SECTION 00 91 11 - ADDENDUM NUMBER 2

Date: February 7th, 2025
Project: NGFD English Road Station - Contracts DEFG
Project Number: 20233530.0001

FIRST FLOOR PLAN
 1816 ENGLISH RD
 NGFD - ENGLISH ROAD STATION
 TOWN/CITY: GREECE
 COUNTY: MONROE STATE: NY
 PROJECT NO.: 20233530.0001
 DRAWING NO.: A-100
 DATE: JANUARY 22, 2025

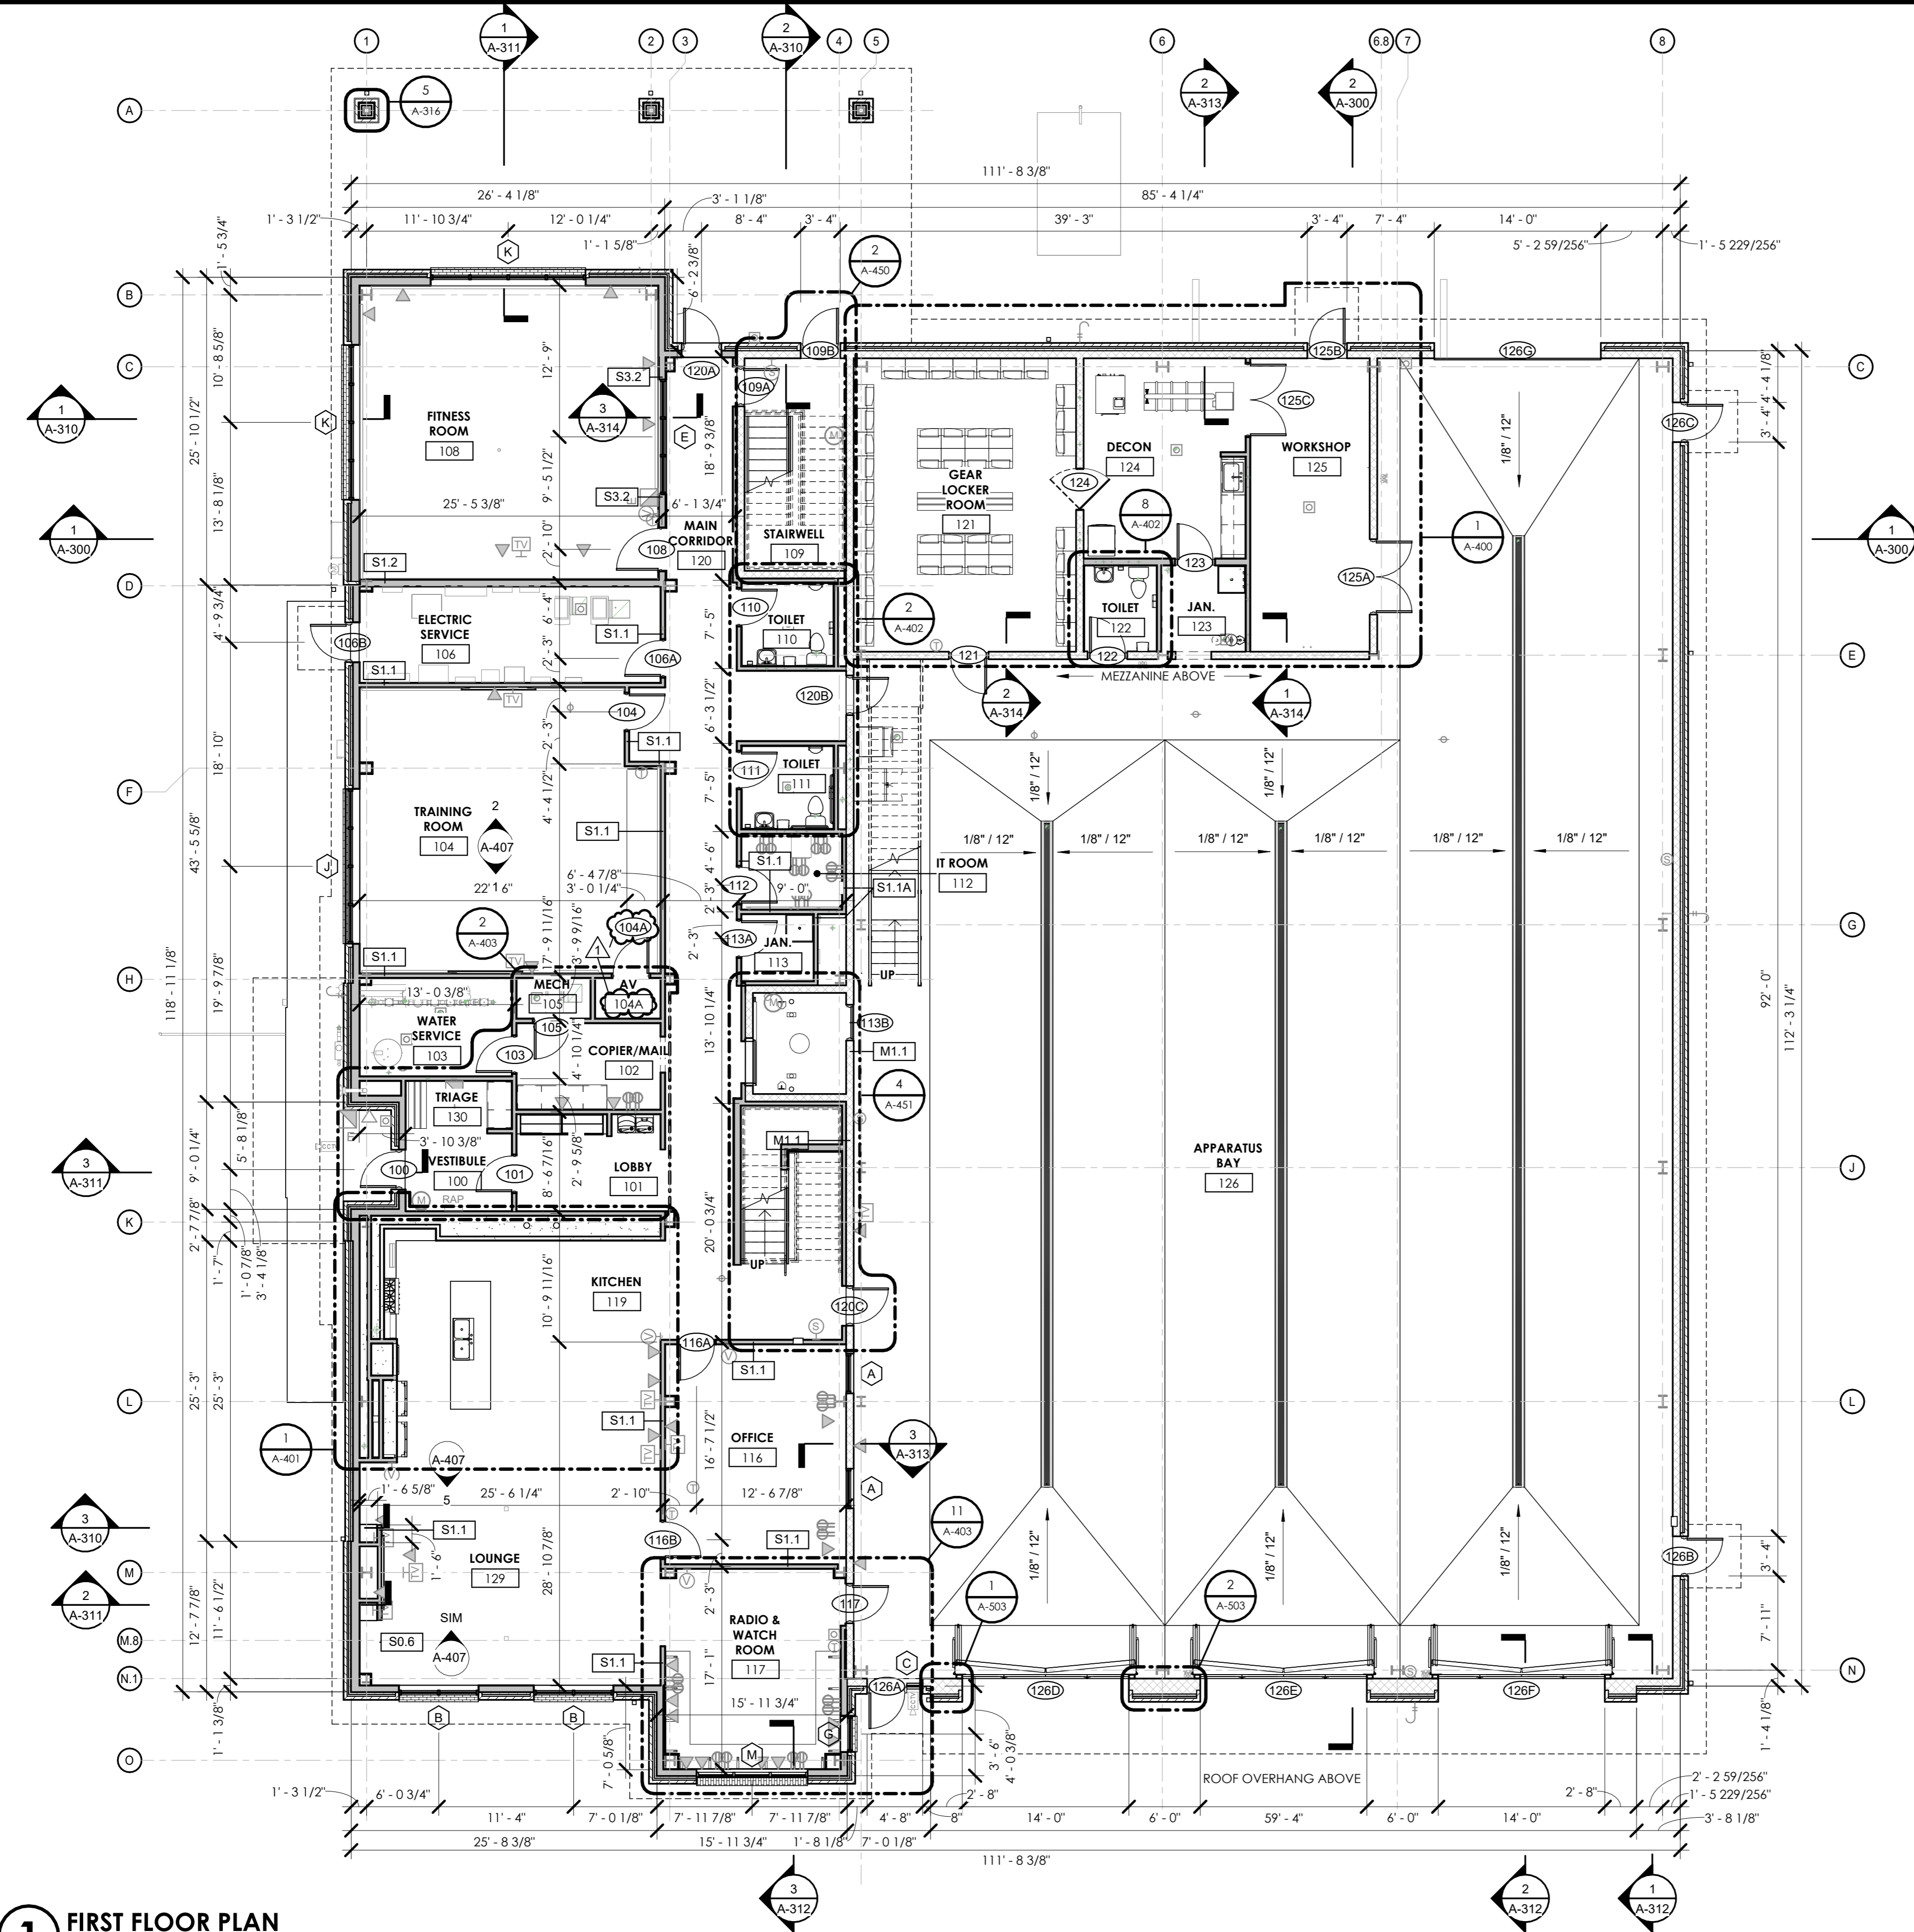
1. A-100 First Floor Plan
 - AV Room Number and Door Number to 104A.
2. A-103 Roof Plan
 - Downspouts added and called out.
3. A-200 Exterior Elevations
 - Downspouts added and called out.
4. A-201 Exterior Elevations
 - Downspouts added and called out.
5. A-318 Wall Section Details
 - Detail 1 revised to reflect correct rainscreen installation requirements.
6. A-400 Enlarged Plans & Interior Elevations
 - Dimensions adjusted along west wall of Workshop.
7. A-407 Enlarged Plans & Interior Elevations
 - Door tag changed to 104A.
8. A-501 Roof Details
 - Box gutter detail dimensions revised.
9. A-600 Door Schedule
 - Door schedule updated.
 - Door frames updated.
 - Glazing types added.
10. A-601 Door Details
 - Door Head and Door Jamb Metal Stud with EIFS added.
11. A-602 Window Schedule
 - Glazing types added for window M.

DRAWING NO.:
 A-600

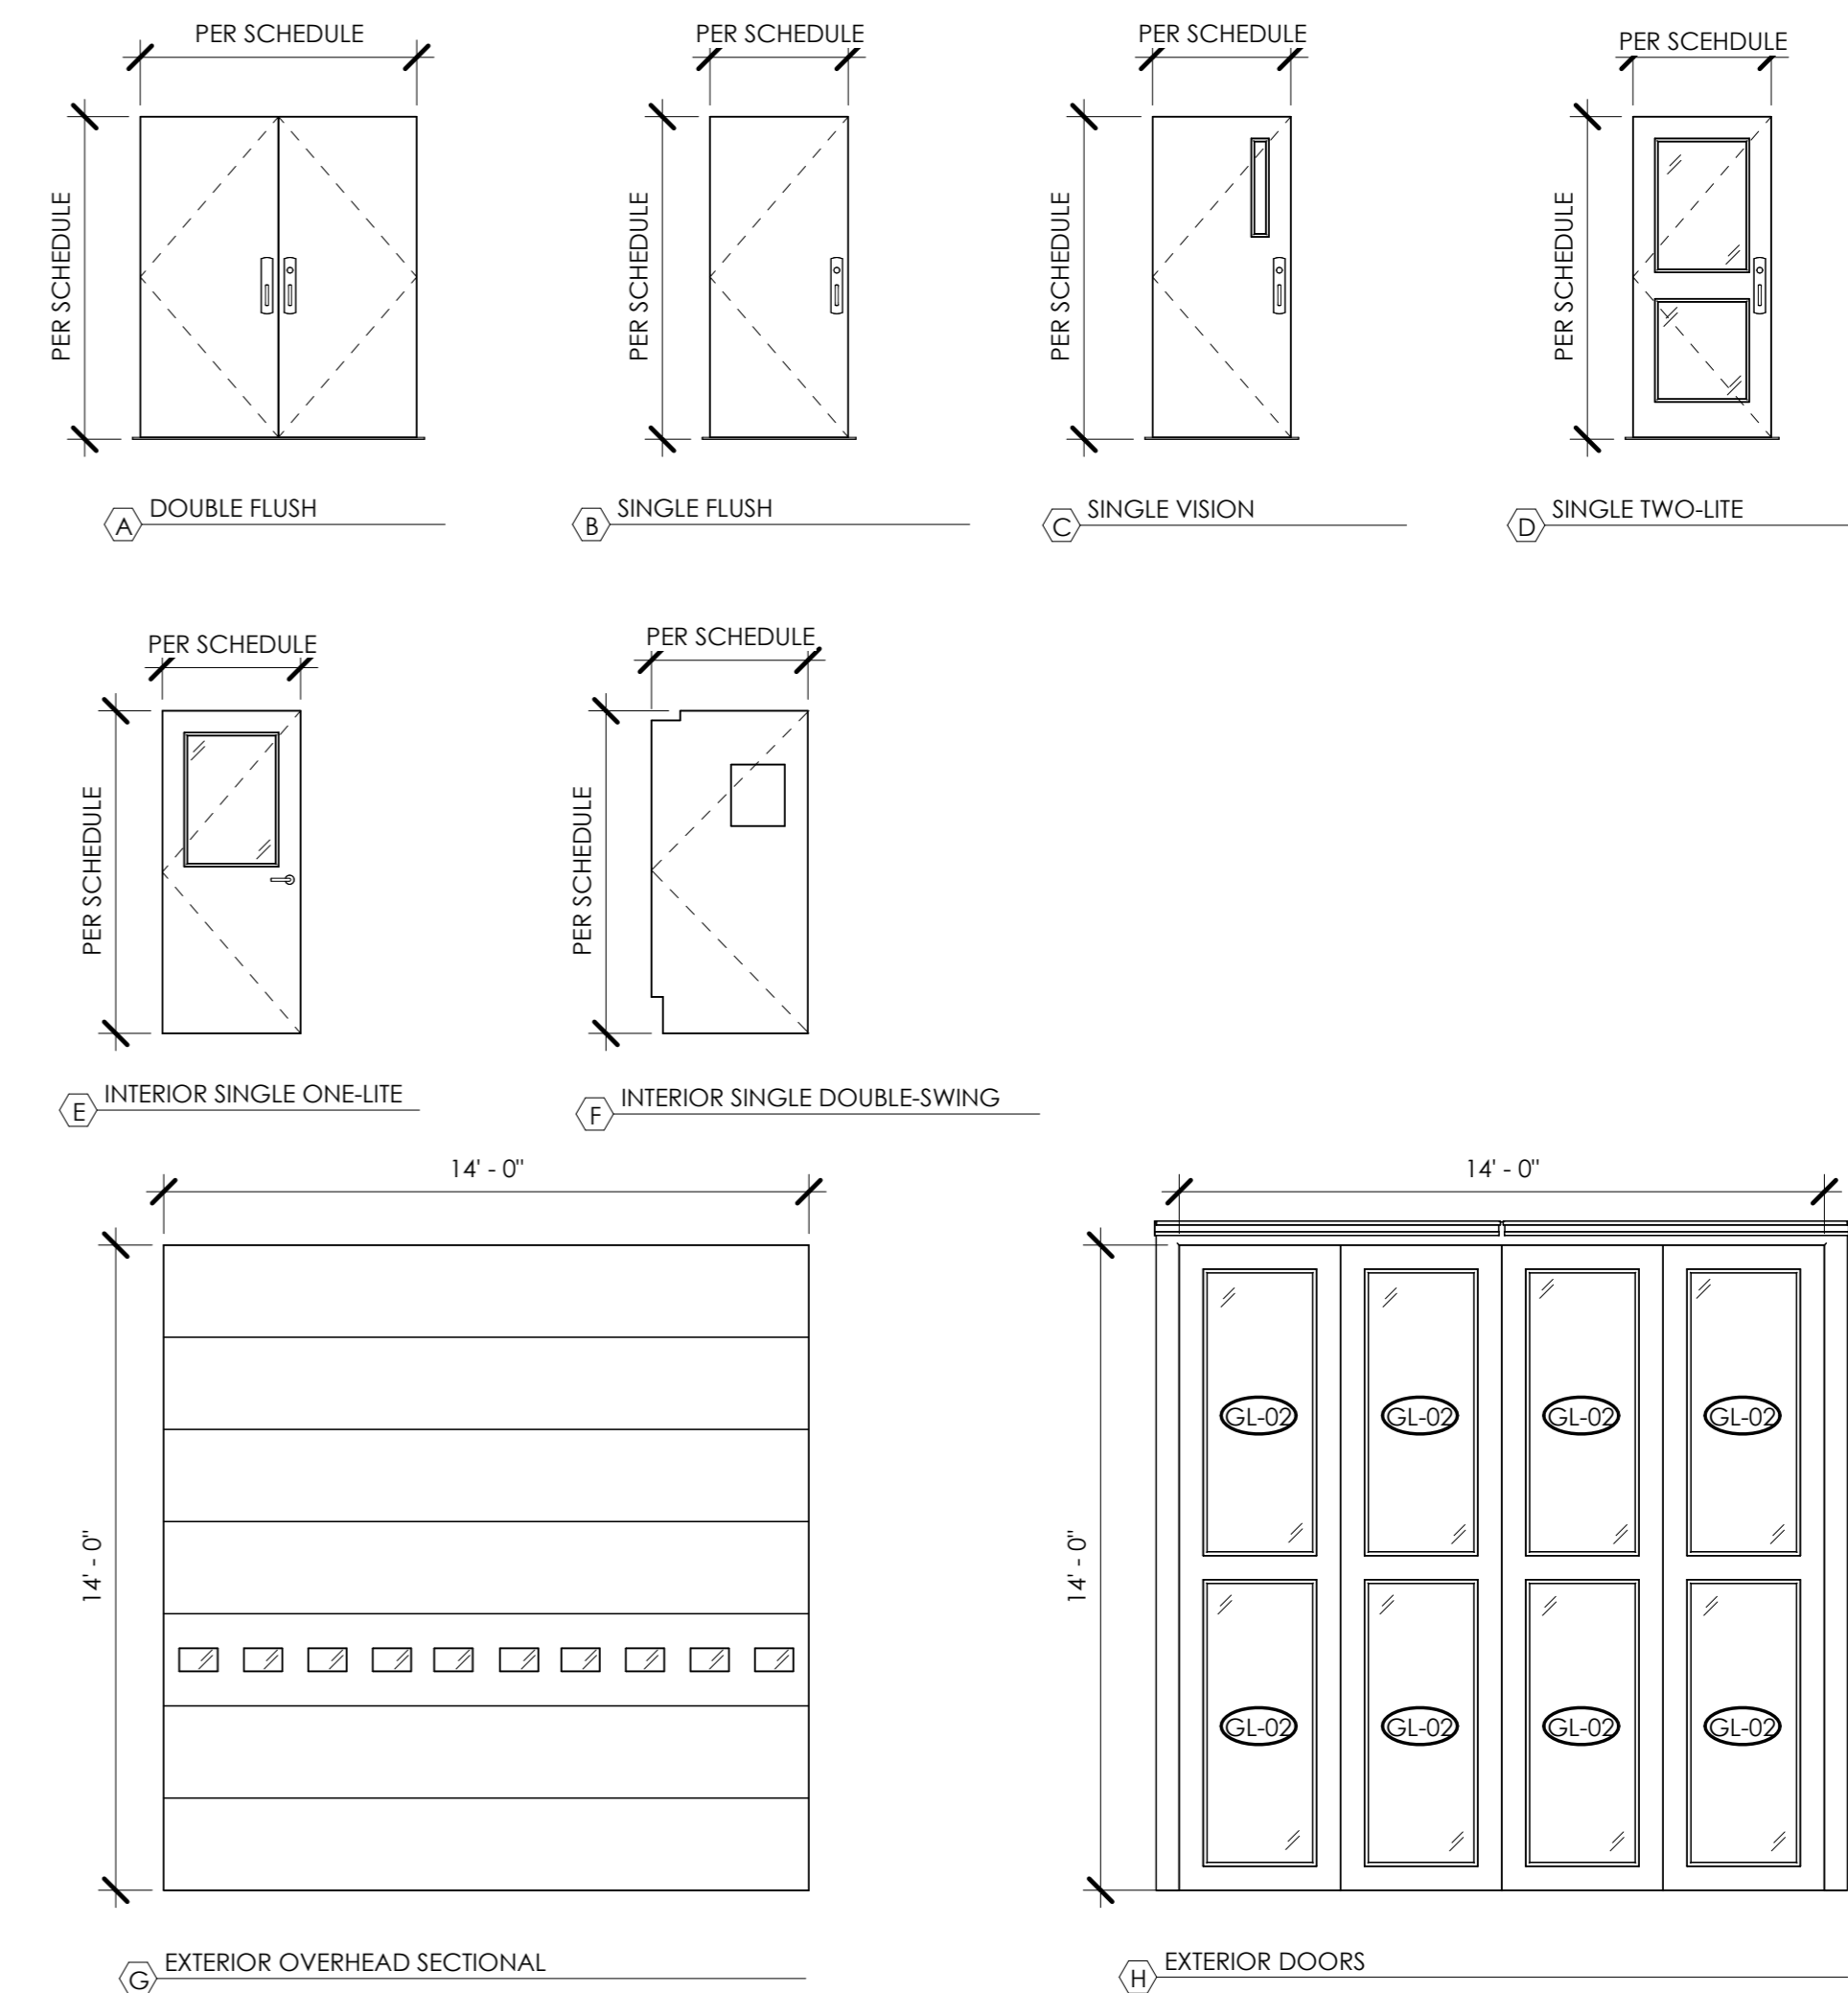
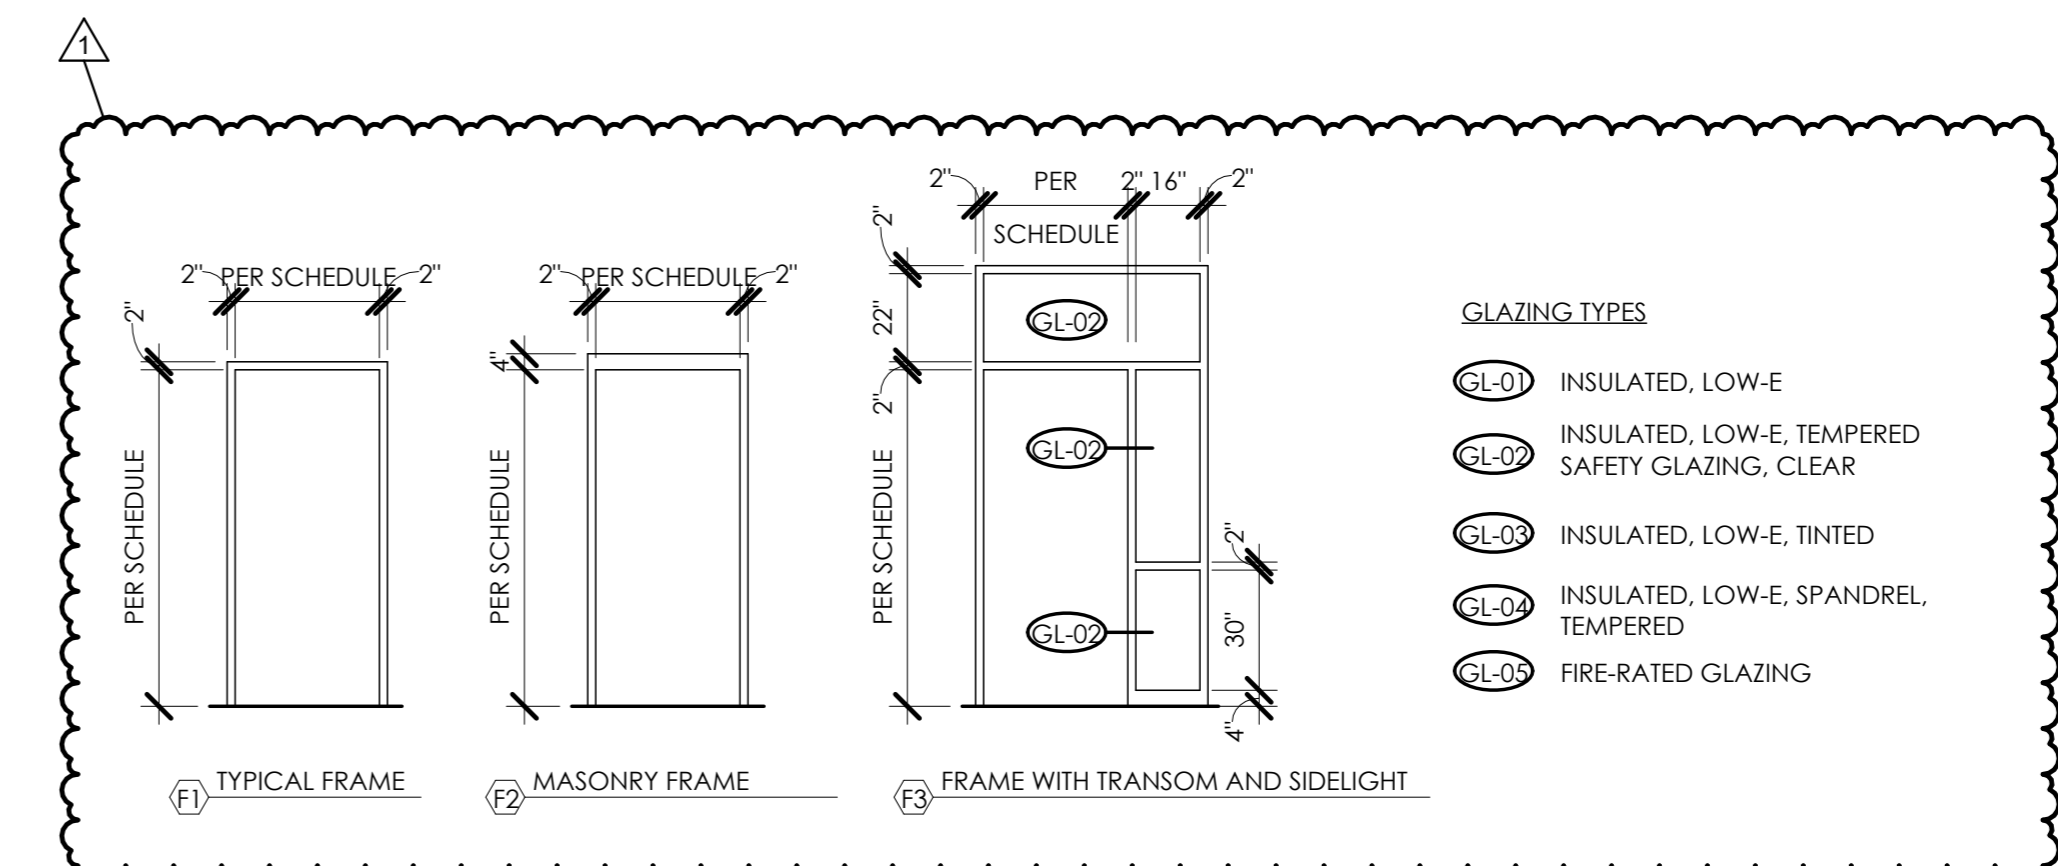
PRFI-02-GC	Door Type	<p>Door Schedule A600 PER ADDENDUM #1 January 30th. Aluminum doors / Frames</p> <p>Door # type D now it call for full view but the style did not change, please confirm no mid rail.</p> <p>Door 106 B calls for door type B flush door, not available in aluminum storefront door, is it a FRP door.</p> <p>Door# 109B calls for a 60 MIN rating door type C. Is that supposed to be H.M. Door with fire glass</p> <p>1. Door type C vision light is not available in aluminum or is it a FRP rated door.</p> <p>2. Door#120A, 125B, 126B, 126C all call out for door type C aluminum door, again not available in aluminum door, are they supposed to be FRP or H.M.</p> <p>3. DOOR # 233 call for type B flush aluminum door, again not available in aluminum storefront door, is that H.M. or FRP.</p> <p>4. If door types C/ B are supposed to be FRP Please provide specs.</p> <p>5. Drawing A-200 South elevation note #16 calls out for Metal panel Rain Screen. Elevation shows a pentagon framing of some sort Detail sheet A-318 ON 1 just shows fix wall.</p> <p>6. Can we get more clarification on what this is please, if panels can we get a detail sheet on how it's supposed to be connected to the w</p>	<p>Door Schedule A600 PER ADDENDUM #1 January 30th. Aluminum doors / Frames</p> <p>1. Door # type D now it call for full view but the style did not change, please confirm no mid rail.</p> <p>Mid rail is correct, elevation D has 2 lite panels</p> <p>2. Door 106 B calls for door type B flush door, not available in aluminum storefront door, is it a FRP door.</p> <p>H.M. Door with H.M. frame, refer to revised door schedule.</p> <p>3. Door# 109B calls for a 60 MIN rating door type C. Is that supposed to be H.M. Door with fire glass.</p> <p>Yes, refer to revised door schedule.</p> <p>4. Door type C vision light is not available in aluminum or is it a FRP rated door.</p> <p>H.M. or Wood Door, refer to revised door schedule.</p> <p>5. Door#120A, 125B, 126B, 126C all call out for door type C aluminum door, again not available in aluminum door, are they supposed to be FRP or H.M.</p> <p>H.M. Door, refer to revised door schedule.</p> <p>6. DOOR # 233 call for type B flush aluminum door, again not available in aluminum storefront door, is that H.M. or FRP.</p> <p>H.M. Door and H.M. Frame</p> <p>7. If door types C/ B are supposed to be FRP Please provide specs.</p> <p>H.M. or Wood Door used for elevation types B and C, refer to revised door schedule.</p> <p>8. Drawing A-200 South elevation note #16 calls out for Metal panel Rain Screen. Elevation shows a pentagon framing of some sort Detail sheet A-318 ON 1 just shows fix wall.</p> <p>Refer to revised metal panel specification and detail 1/A-318 for additional mounting installation information.</p>	Kurt Van Heusen	Quille Hughes; Paul Lucas	2/5/2025	2/7/2025	3

PRFI-04-GC	Aluminum Doors	Regarding aluminum door #'s (106B, 109B, 120A, 125B, 126B, 126C & 233) should be changed to an FRP door Special Lite series: SL-17.	Refer to revised door schedule.	Tonya Minnamon	Quille Hughes; David Dangelantonio; Paul Lucas	2/6/2025	2/7/2025	2	
PRFI-05-BC	Steel, Part II	<p>1. Can this project bid date be extended? Joist and deck vendors have noted that do to holiday closure the morning of 1/9 is a tough date to get pricing to us by.</p> <p>2. Is there a Non-Collusive Form to fill out, Bid Form states there is but I do not see one as part of the Specs provided.</p> <p>3. The 05-12-00 specs state that the Steel Erector must be AISC Certified, can this requirement be waived? Ramar is certified as a fabricator but not as an Erector however we have done numerous project with the Town of Greece, Christa and Passero in the past. Ramar does erect in accordance to AISC practices. There are only a couple certified erectors in the this region. If this is not waived, Ramar will not be able to bid this project being a prime contract.</p> <p>4. Are there Architectural plans available (we only have structural plans), or can you give me the height and width of the Apparatus Bay OH Doors to price the embed plate sill needed at them (6/S301) and Channel Jamb (12/S301)</p>	<p>1. Yes bid opening will be on 1/16.</p> <p>2. Non-collusive statement is included on the bid form.</p> <p>3. Yes, the steel erector AISC certification listed in specification 05 12 00 section 1.05.E may be waived.</p> <p>4. Yes, architecture floor plans and elevations are provided as part of Addendum #1. The overhead/folding doors are generally 14'-0" x 14'-0".</p>	Jason Spitulnik		1/7/2025	1/7/2025	1
